STAFF RECOMMENDATION
1401 Ashwood Avenue
March 18, 2015

Application: New construction-addition
District: Belmont-Hillsboro Neighborhood Conservation Zoning Overlay
Council District: 18
Map and Parcel Number: 10513006300
Applicant: Kristen Newton, Allard Ward Architects, LLC
Project Lead: Paul Hoffman, paul.hoffman@nashville.gov

<p>Description of Project: Construction of an addition to the rear of the home.</p> <p>Recommendation Summary: Staff recommends approval with the conditions:</p> <ol style="list-style-type: none"> 1. Staff approve the final details, dimensions and materials of windows prior to purchase and installation; and, 2. Staff approve the roofing color; 3. HVAC and other utilities are located to minimize their visibility from the street. <p>Meeting these conditions, Staff finds the project meets the design guidelines for the Belmont-Hillsboro Neighborhood Conservation Zoning Overlay.</p>	<p>Attachments A: Photographs B: Site Plan C: Elevations</p>
---	--

Figure 2. Proposed window change on the left side of the house.

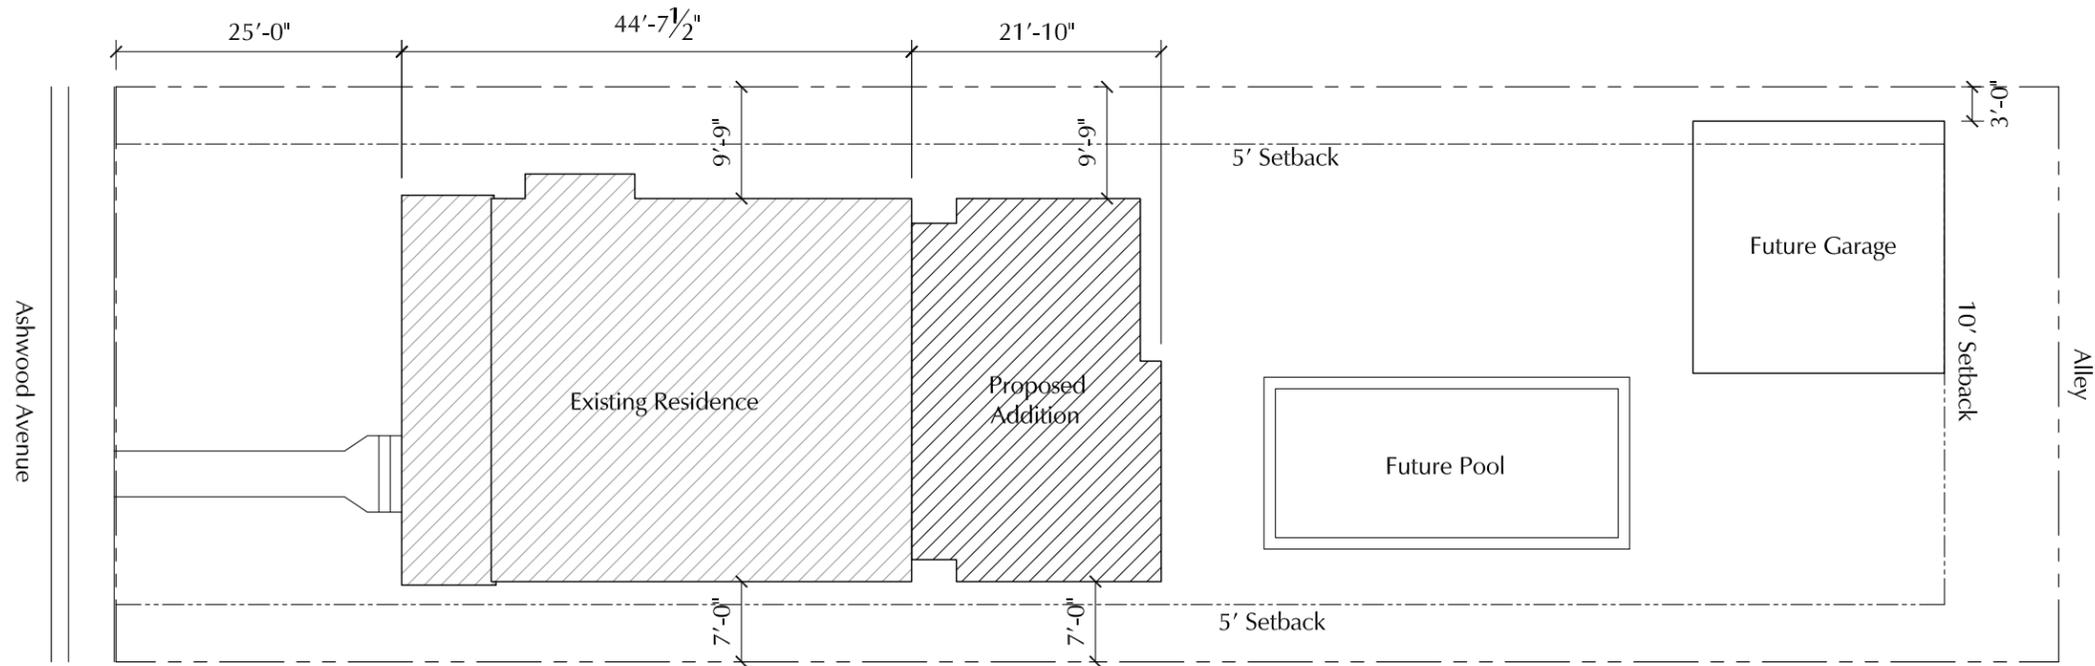
Demolition: The addition calls for demolition of most of the house’s rear wall. At the rear of the left side, some existing bricks will be removed and re-laid in order to add a third window there. Two existing windows at the rear of the left side are proposed to be moved and have a third window added. The rear of the house is not visible from Ashwood Avenue. The proposed window change is at the rear corner of that side of the house, past the midpoint. Staff’s analysis is that the partial demolition will not be detrimental to the historical or architectural integrity of the house, and the application meets section III.B.2 for appropriate demolition and does not meet section III.B.1 for inappropriate demolition.

1 East Elevation
 Scale: 1/8"=1'-0"

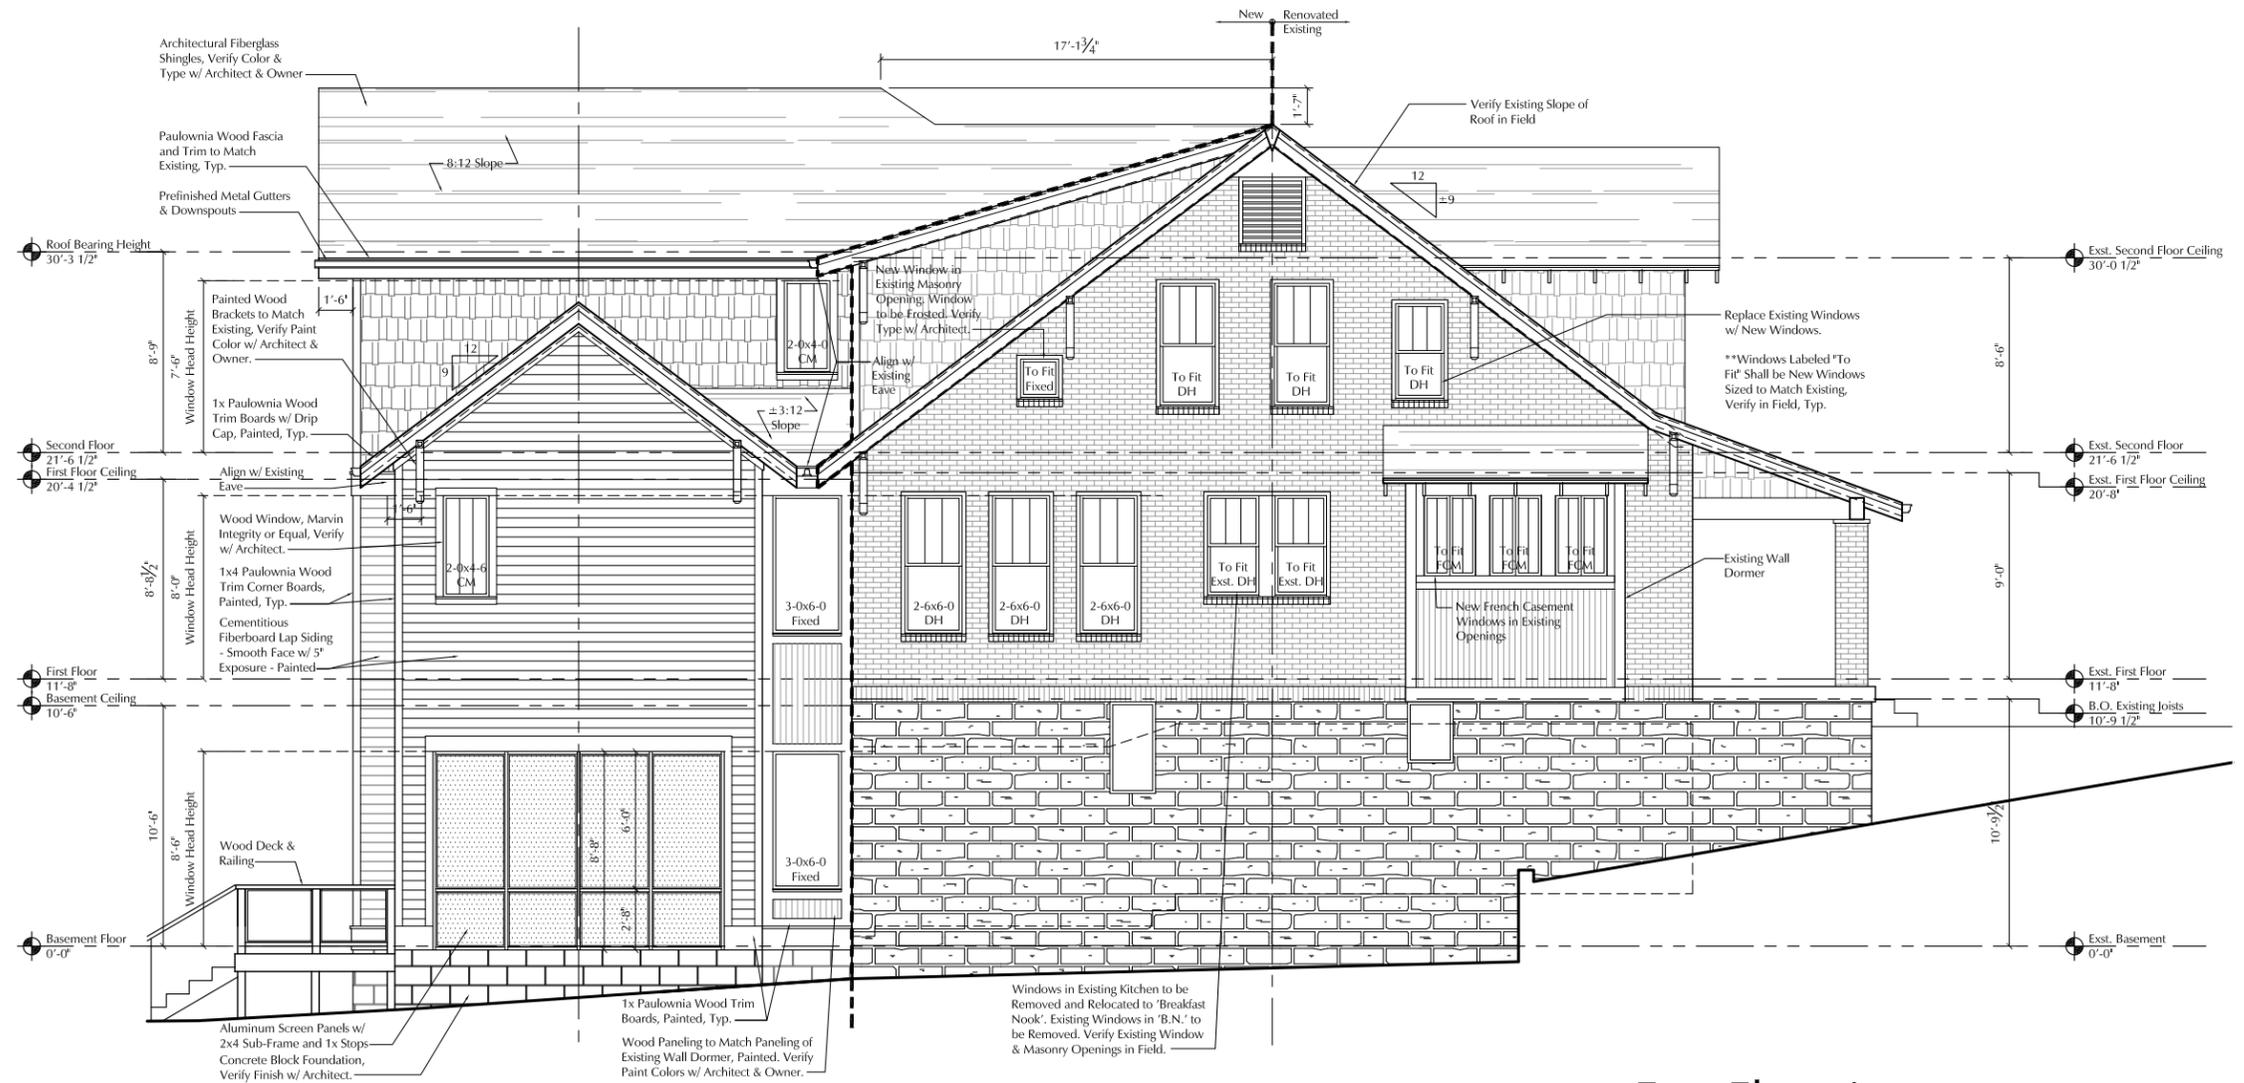
Proportion and Rhythm of Openings: The windows on the proposed addition are generally twice as tall as they are wide, thereby meeting the historic proportions of openings. The longest expanse of wall space without a window or door opening is eleven feet (11') on the east side of the addition. Staff finds the project's proportion and rhythm of openings to meet Section II.B.1.g.

1 West Elevation

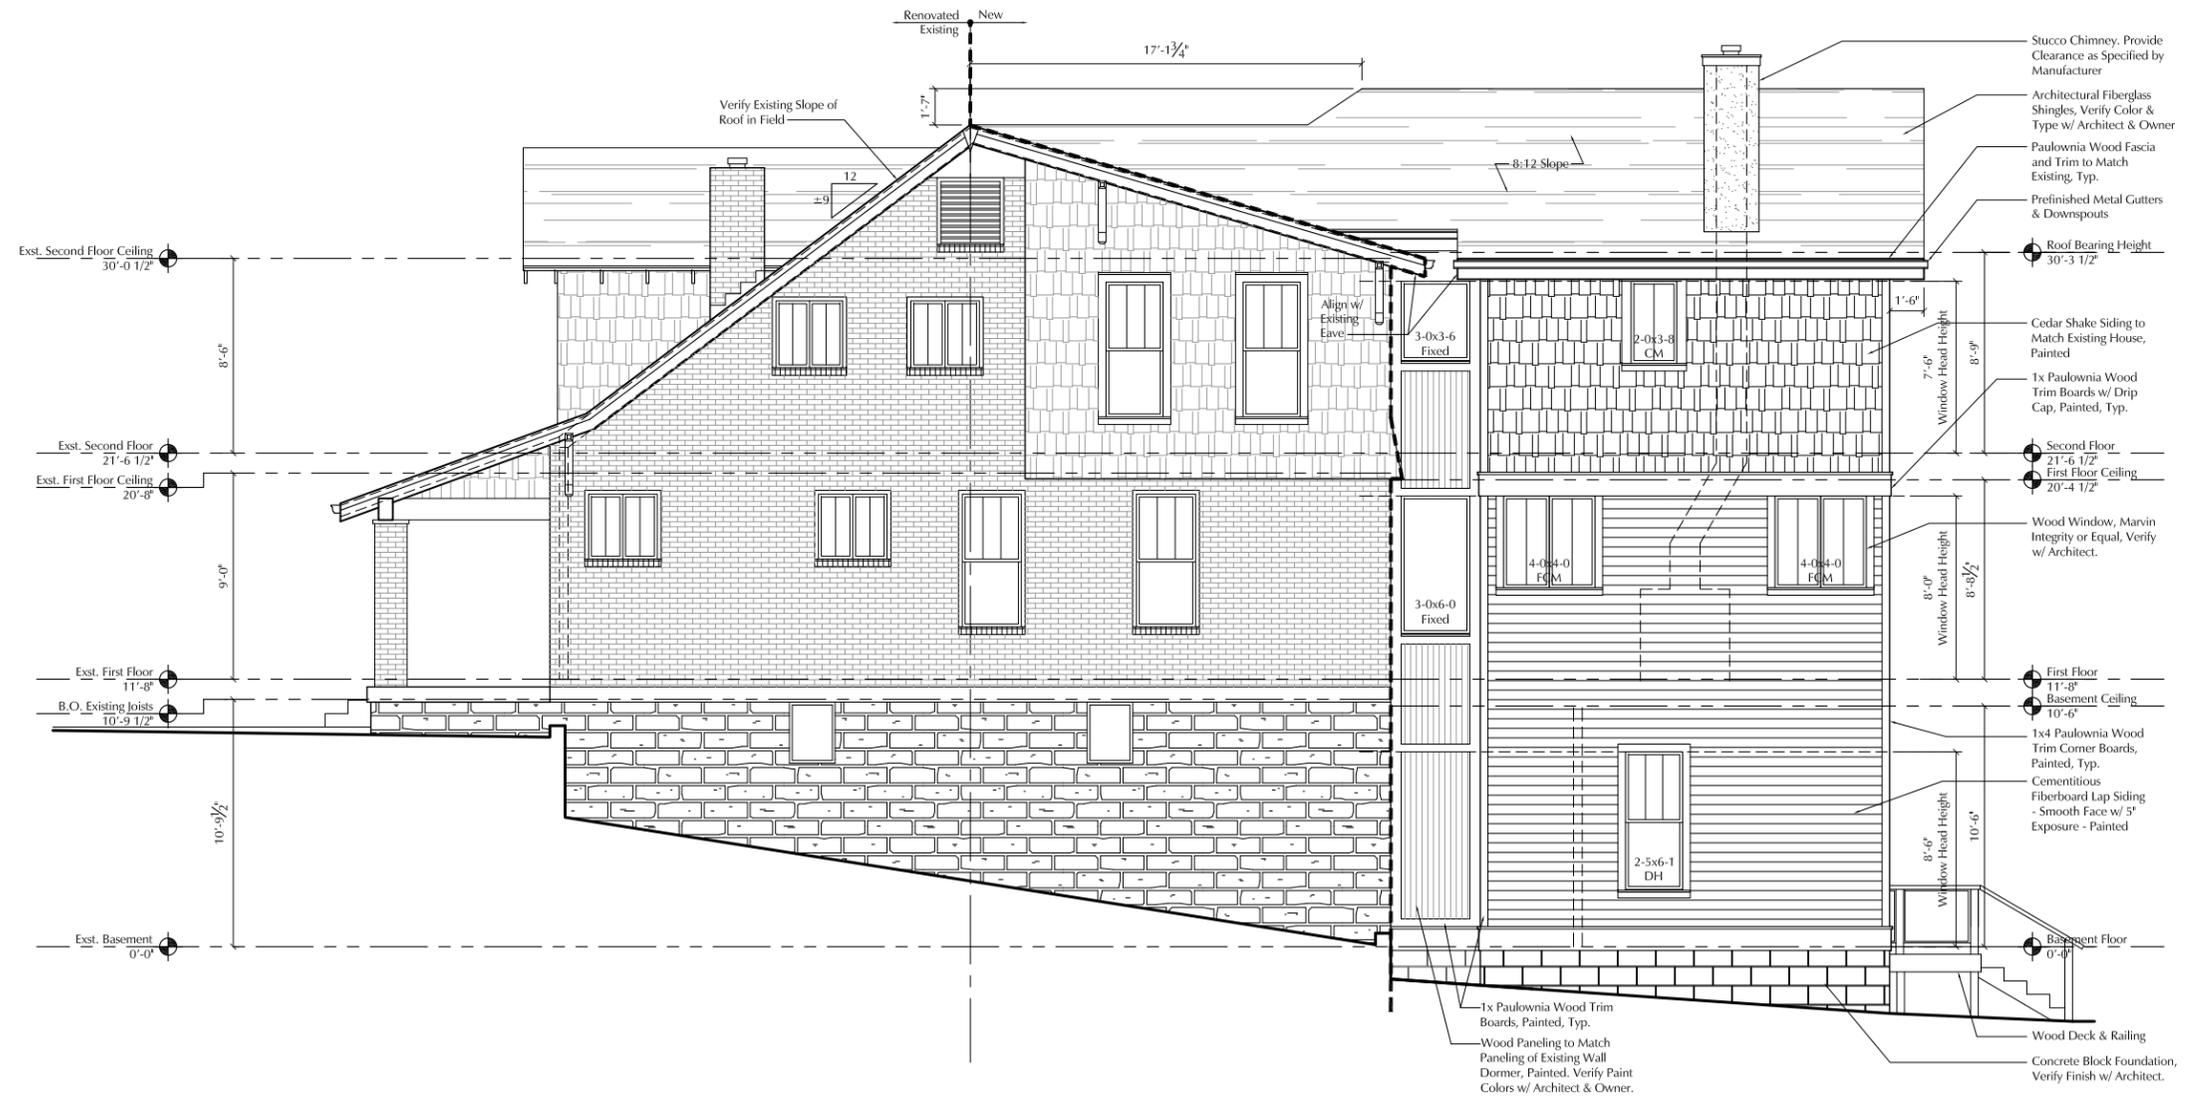
Roof form: The addition has a gabled roof with 8/12 pitch and a lower side-gabled portion with 9/12 pitch. An interior chimney will be built on the addition's west side. The roof forms are compatible with the context. The project meets section II.B.1.e.
